Project name: GOC5370560 - Elections Canada

Clarification 02

The following information supplements and/or supersedes the bid documents issued on 17-10-2024.

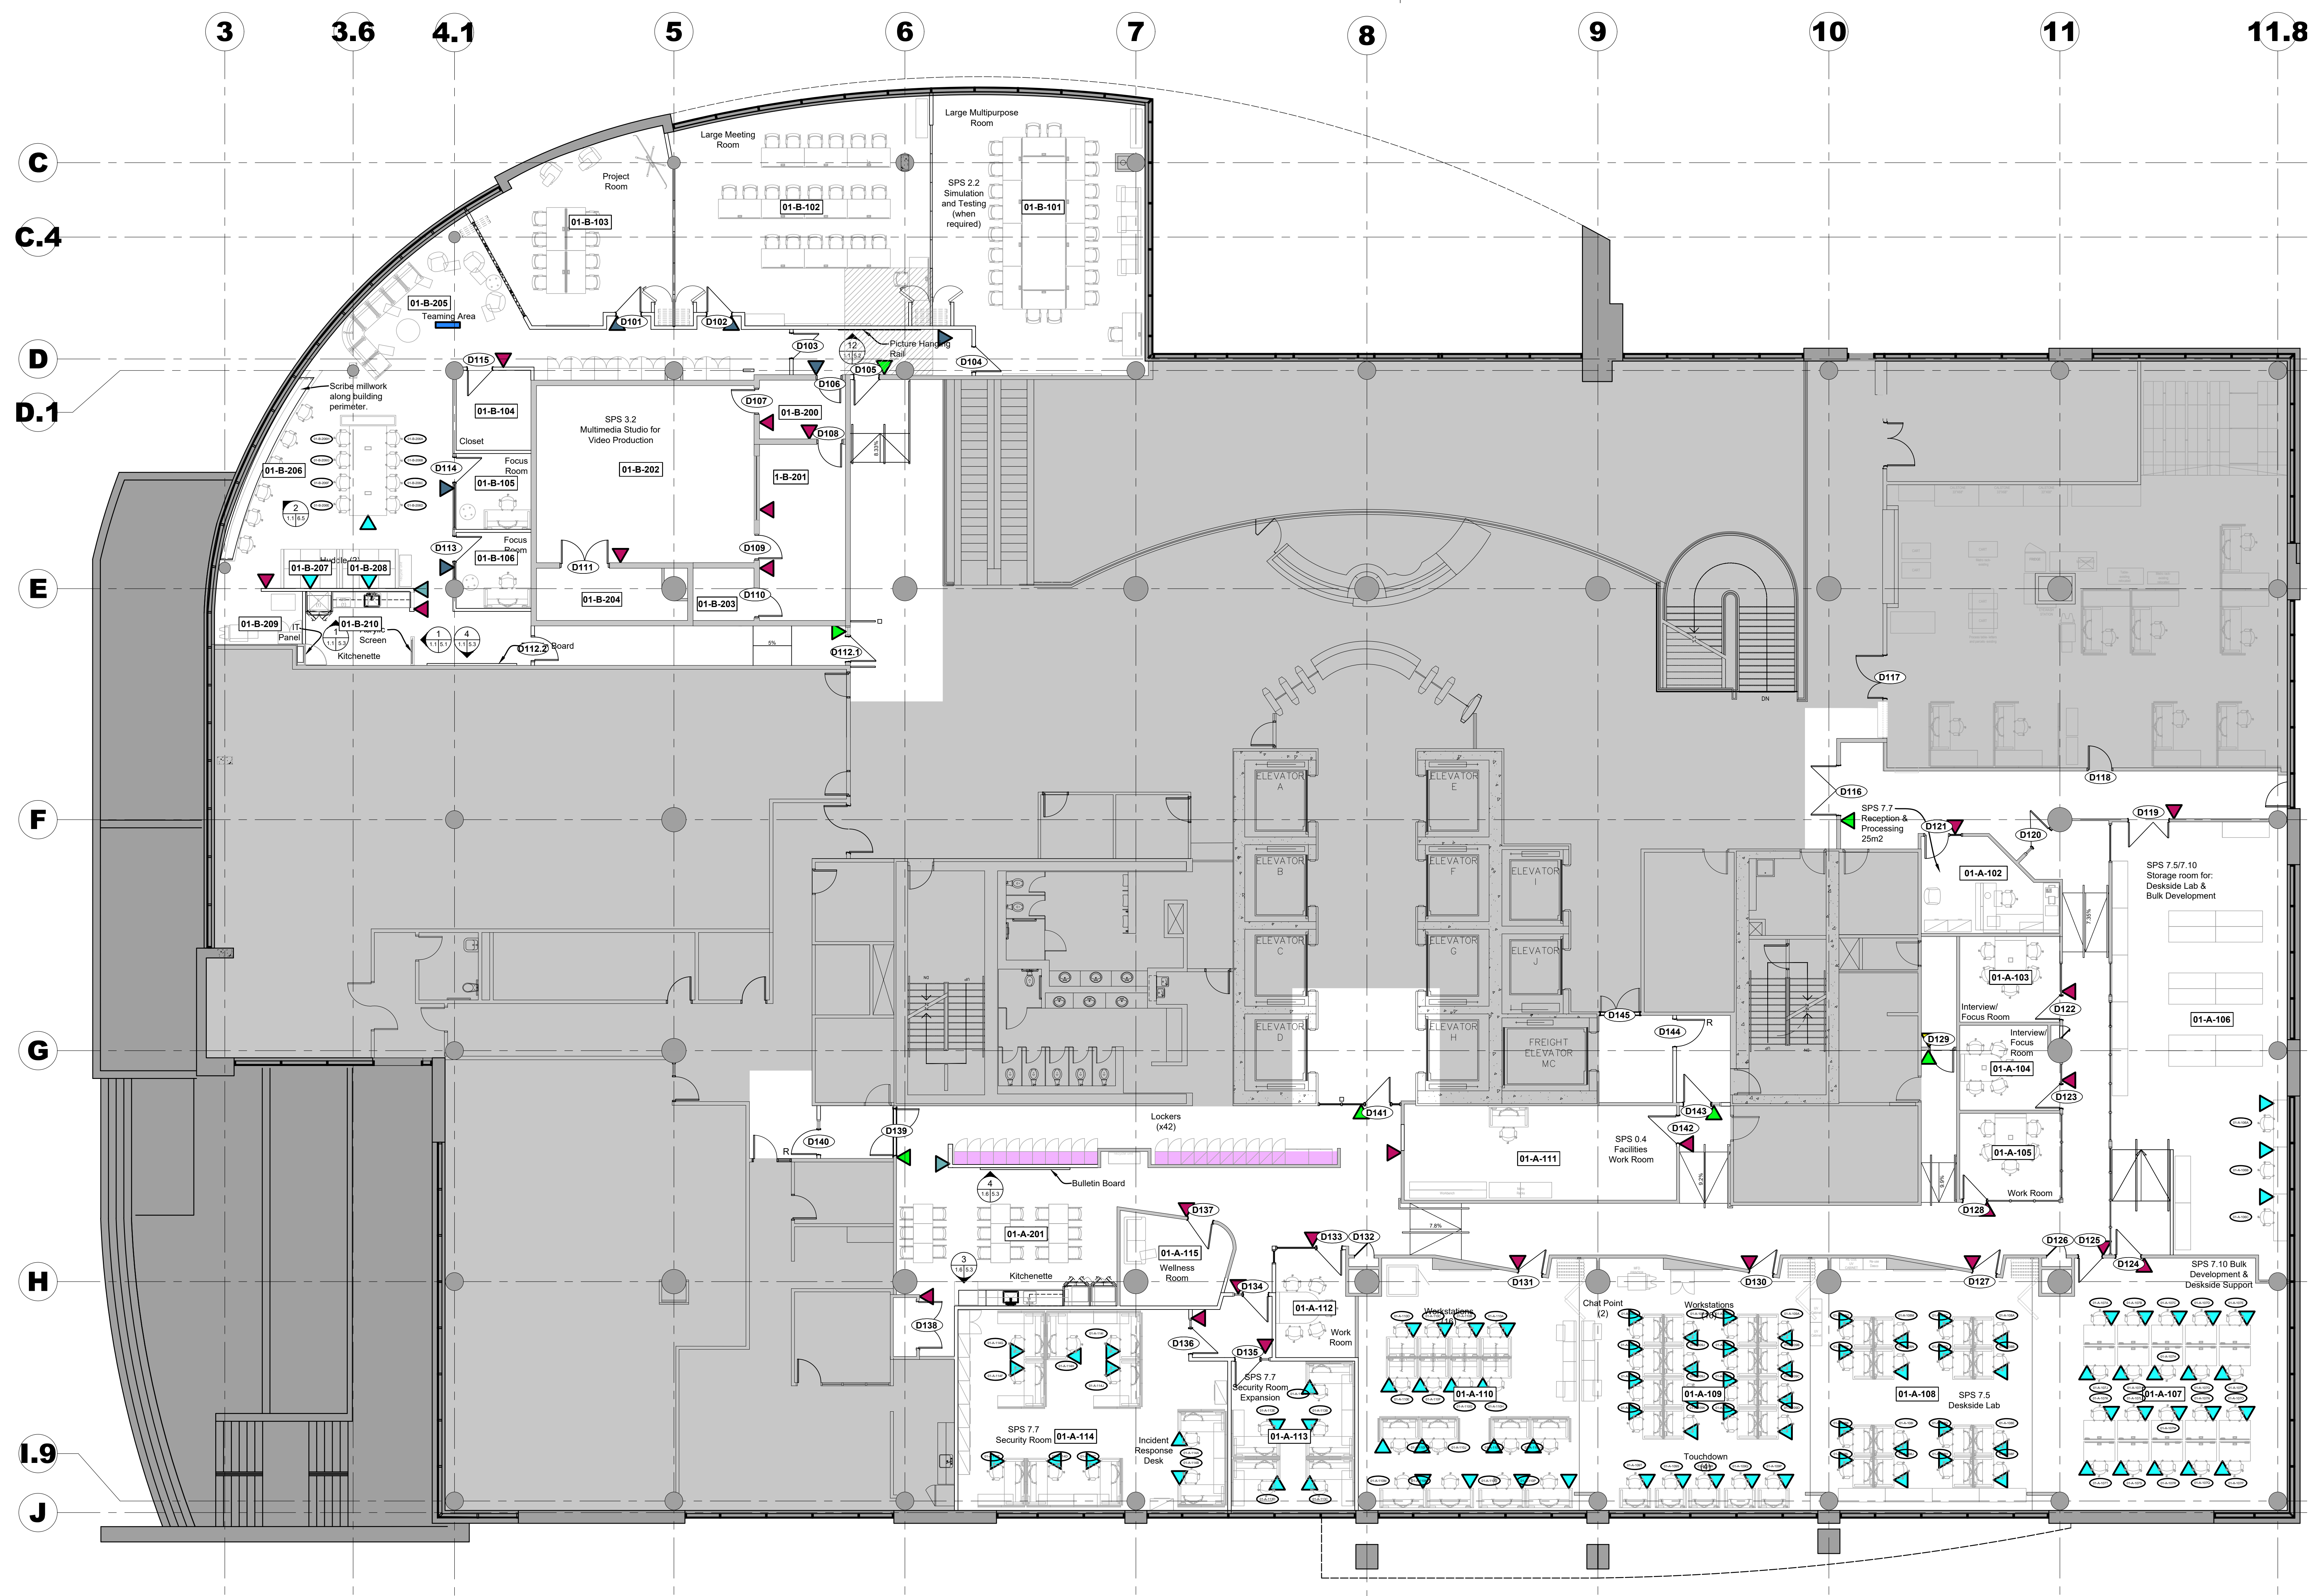
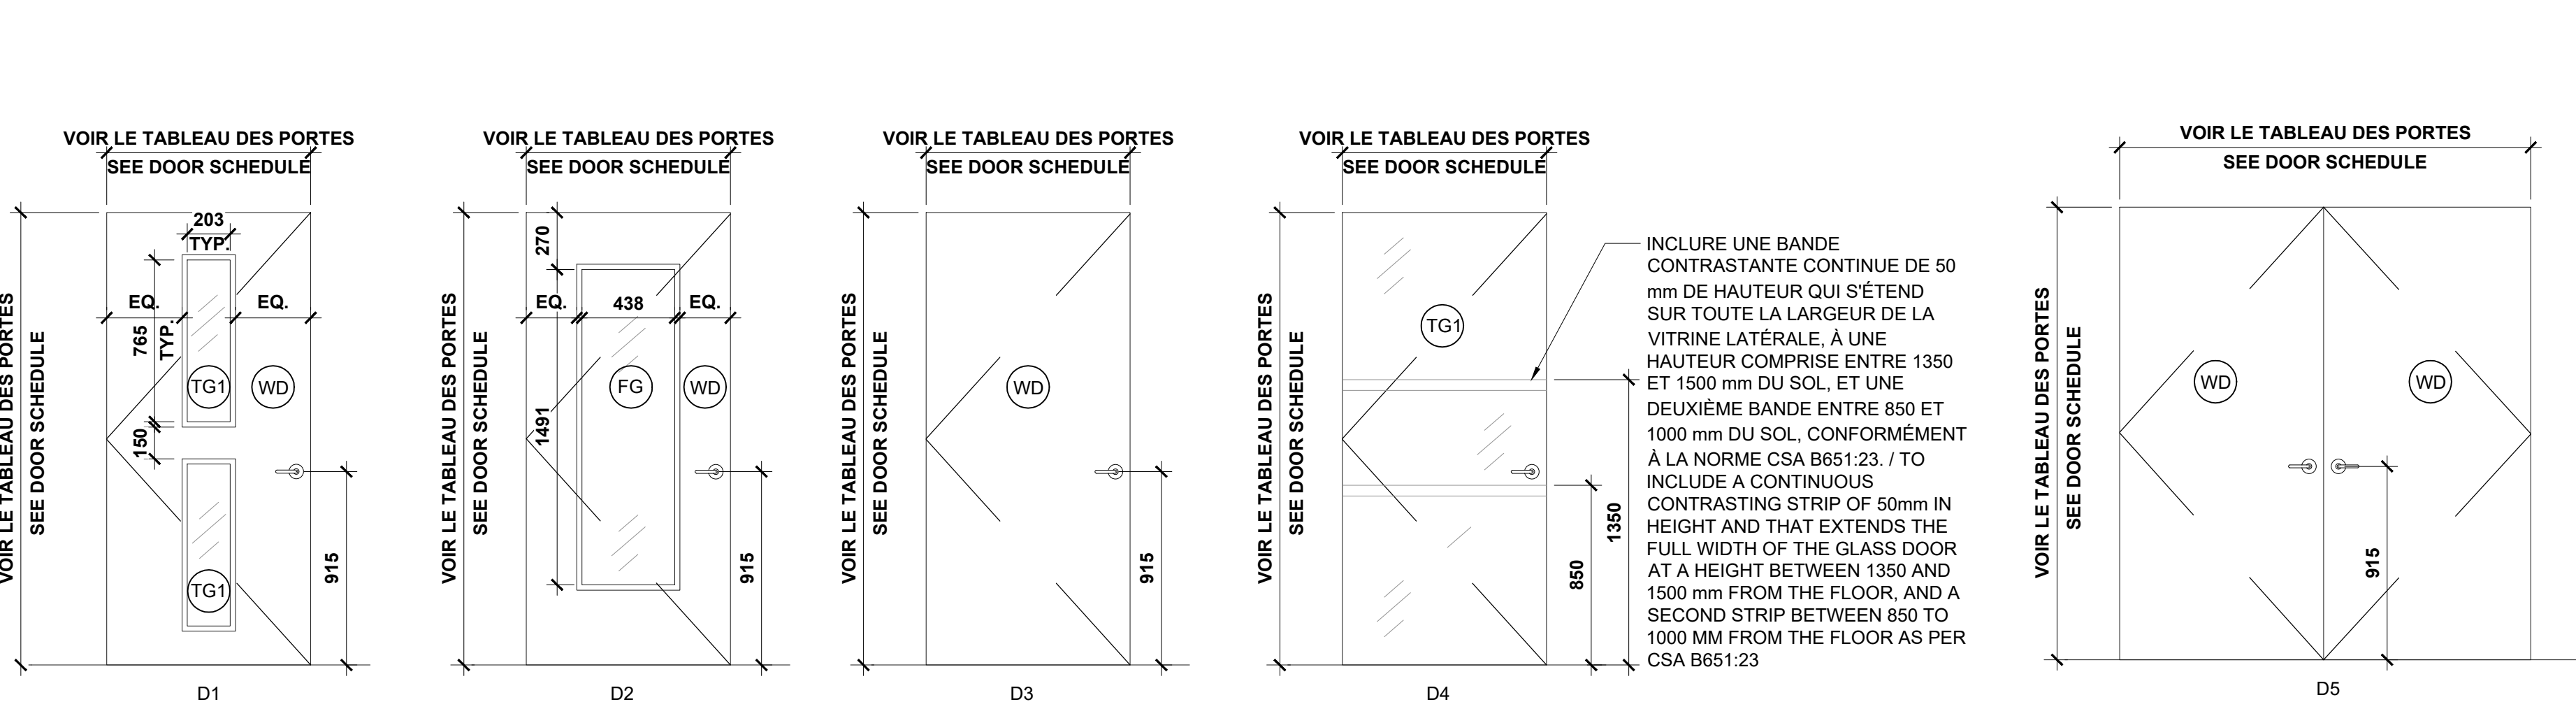
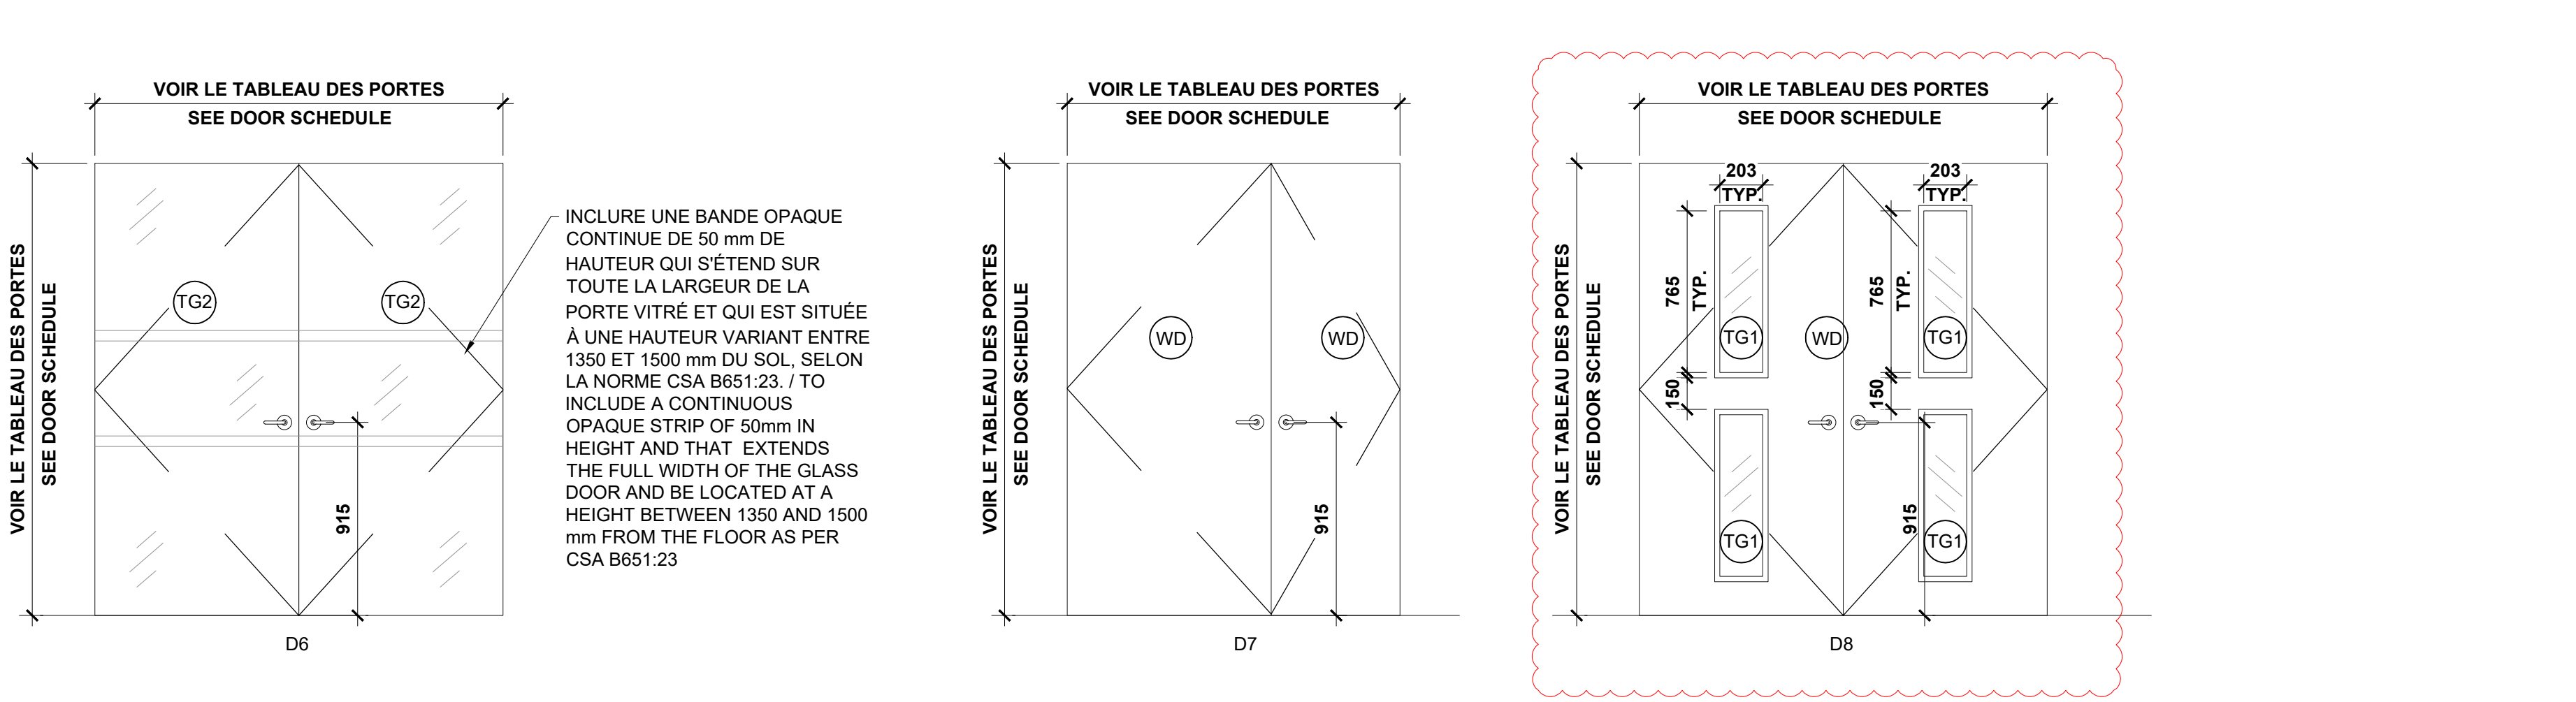
- Please attached revised door schedule. These replace page A800 and A801 (English and French plans)
- Clarifying that finishes of new moveable walls type W7 located at between 01-B-103/01-B102/01-B-101 (note-C06), are to match finish of existing moveable wall to be reinstalled (note C-07).

Designed By	Conçu par
Date	
Drawn By	Dessiné par
Date	
Reviewed By	Examiné par
Date	
Approved By	Approuvé par
Date	
Tender	Scoumission
Project Manager	Administrateur de projets
Project no.	No. du projet
GOC5370560 - R.124213	
Drawing no.	No. du dessin
ID 3.6

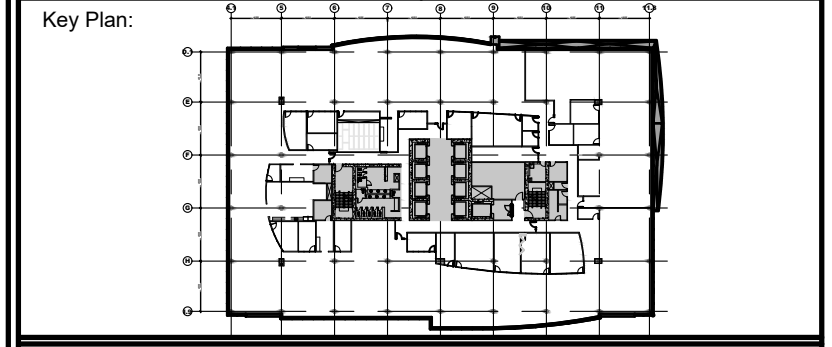
- Please see attached revised interior design signage plans. These replace pages ID1.6, ID1.7, ID3.6, ID3.7, ID4.6, ID4.7
